23/1130/MP Southgate Redevelopment

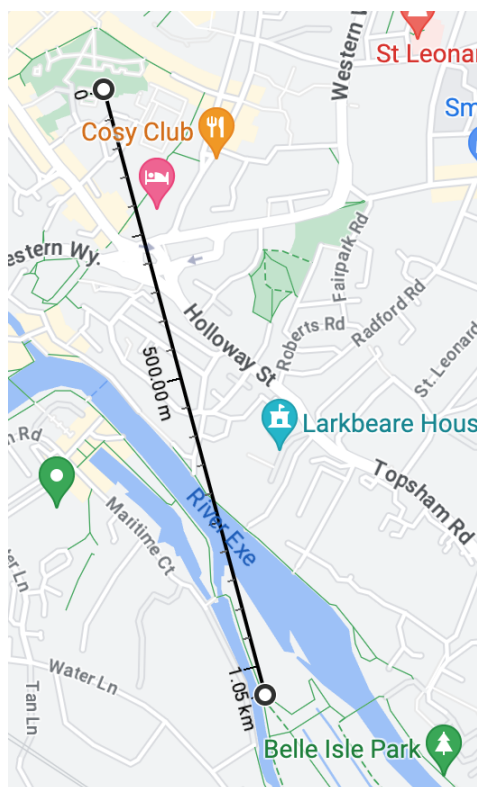
In terms of cycle access to the stores, it also appears that conflict with pedestrians is currently being designed in. The access plan shown in section 8.2.2 of the Design and Access statement is included below.

The cycle stores in Blocks 2 and 3 are both accessed only by “Dismount cycle routes” (yellow dotted lines). If as the name suggests it is intended that cyclists dismount and wheel their bikes, this seems likely to lead to conflict. Many people cycling will cycle all the way to the stores whether this is what the designers intended or not and pedestrians may resent this infraction, leading to conflict. At this design stage the routes should be made safe for shared use, allowing people cycling to reach the stores on their bikes and pedestrians to feel safe.
